SERVICE Counselor

PACKARD DIVISION

VOL. 30, NO. 1

JANUARY, 1956

Fig. 2

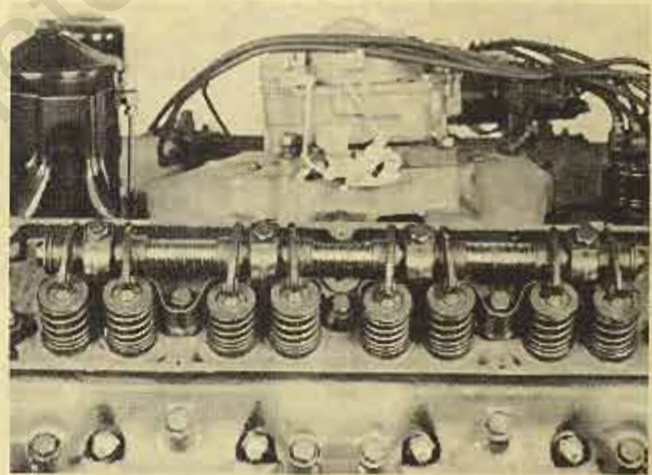
In the very near future, production will use valve spring baffles that will be installed under the valve springs with a flange that extends upward on the high side of the spring to prevent excessive oil from getting on the intake valve stems.

Because of the expense involved to install this type baffle, service baffles have been released that can be installed without removing the cylinder heads.

b. Place the baffles in position on the rocker assembly as shown in figure 2, and install the assembly on the cylinder head. Replace the rocker shaft bolt lockwashers with the square type lockwashers.

that the square lockwashers do not turn with the bolts as the baffles might be distorted.

c. Check the clearance between the baffles and the valve springs. If touching, bend the baffle away slightly with a screwdriver. Install the rocker covers using new gaskets.

Push Button Control Relay

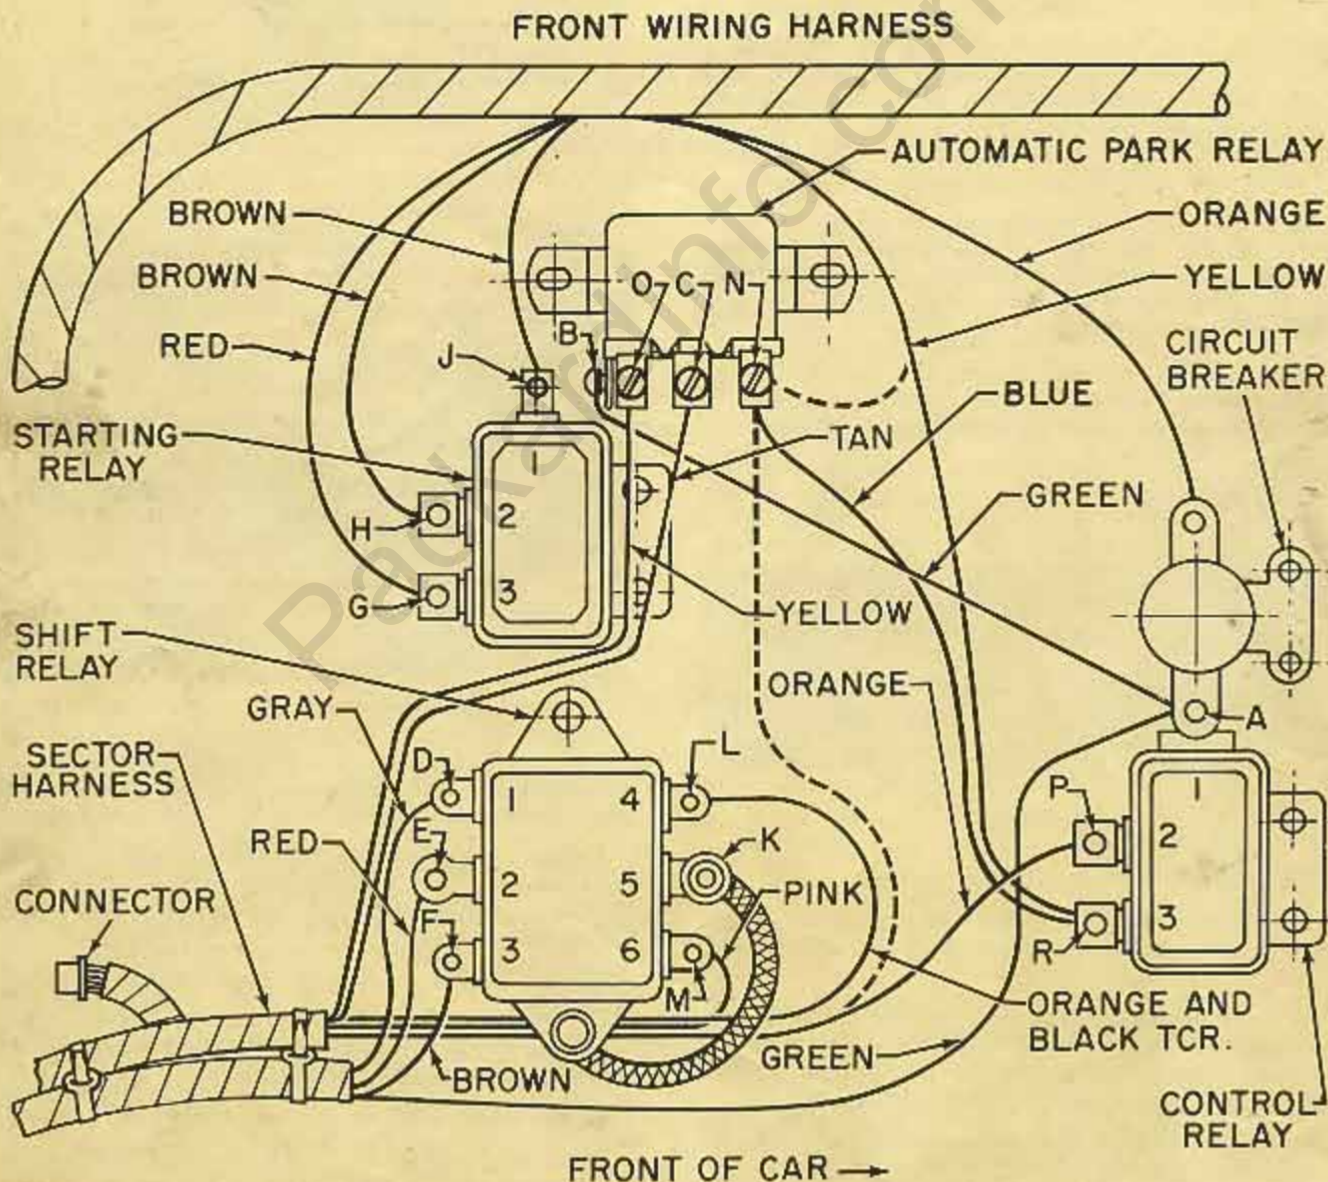
Since adding the Automatic Park Relay to the push button electrical system, it has been found that the control relay functions can be accomplished in the Automatic Park Relay.

Late production cars equipped with push button control do not have the control relay and the necessary wiring has been connected to the automatic park relay.

We suggest the control relay be removed from early production cars and the wires connected as follows:

1. Remove and discard the blue wire that leads from "R" terminal on the control relay to "N" terminal on park relay.
2. Disconnect yellow wire from "R" terminal on Control relay and connect to "N" terminal on park relay as indicated by dotted line on the illustration.
3. Disconnect orange wire from "P" terminal on

control relay and connect to "N" terminal on park relay indicated by dotted line.

4. Remove the control relay, leaving the two green wires connected to terminal "A" on the circuit breaker.

Push Button Relay Water Trough

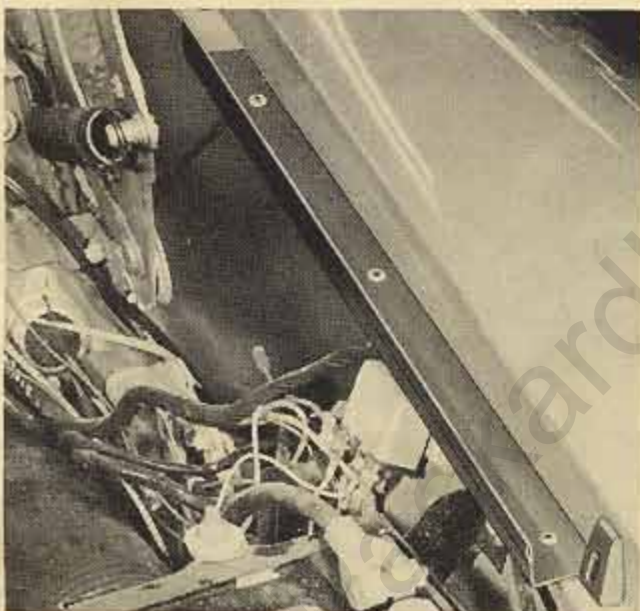
We have been informed that water is getting into a few of the push button control relays causing the relays to short.

Production is now installing a water drain trough which is attached to the flange of the left front fender just above the relays.

The water trough is available for service and should be installed on all early production cars with push button control.

Position the trough on the fender flange with its forward end against the center hood bumper.

Drill three $\frac{1}{8}$ " holes in the fender flange. Apply a coat of dum-dum on top of the fender flange and attach the trough with the three sheet metal screws as shown in the illustration.

Push Button Light Leak

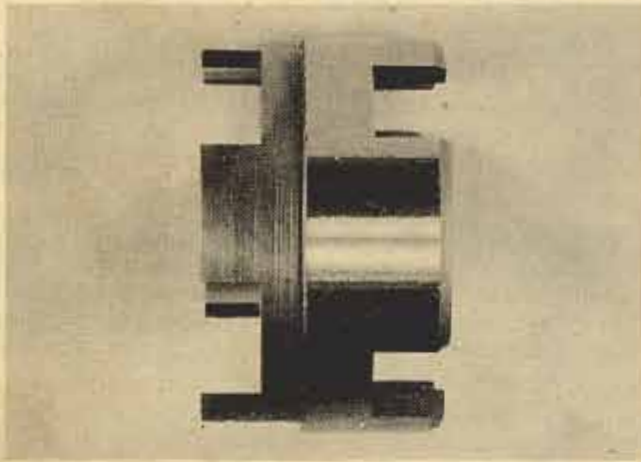
A slight light leakage around the Ultramatic push button control buttons may be found on a few of the early production 56th Series Cars.

A recent alteration, effective in production Nov. 8th, added a felt pad under the push button trim plate which eliminates the slight light leakage.

If some owners should complain of this condition on the early production cars, the felt pad may be installed as follows:

1. Remove the four bolts that clamp the two halves of the switch bracket to the steering column and remove the brackets.

Lift off the switch trim plate, install the felt insulator over the buttons and reinstall the trim plate.

2. Engage bosses of the lower half of the switch bracket with steering column cut-outs and press into place. Compress the felt insulator by pressing on the switch trim plate and carefully position the switch assembly in the groove in the lower bracket.
